IRIS Touch NG Firmware Enhancements and Additions Version 2.32

This document details changes to the IRIS Touch NG range and IRIS Connect from firmware Version 2.23 and 2.31 (Touch 440NG-4G) to Version 2.32.

Honeywell Flex V3 Support

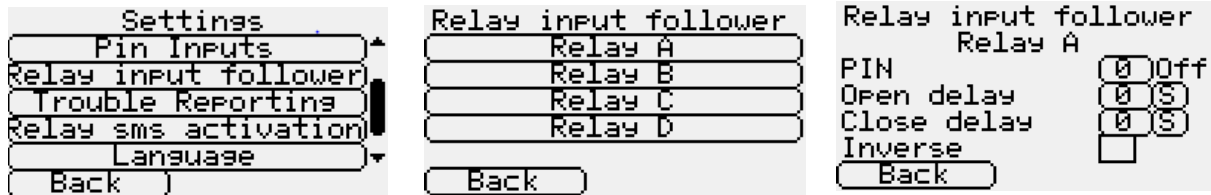
Until recently Honeywell's Flex 3 panels have used Honeywell's high speed RS485 bus for connection to communications devices, which has precluded connection to IRIS diallers which offer the low-speed RS485 bus. However, Honeywell have now released a version of Flex software (3.37 and later) that implements a low speed bus for communications, and IRIS software has been updated to support this bus connection. This means that IRIS diallers can now be used with Flex version 3 alarm panels.

Please contact Chiron for further information on how to set up the alarm panel to use this feature.
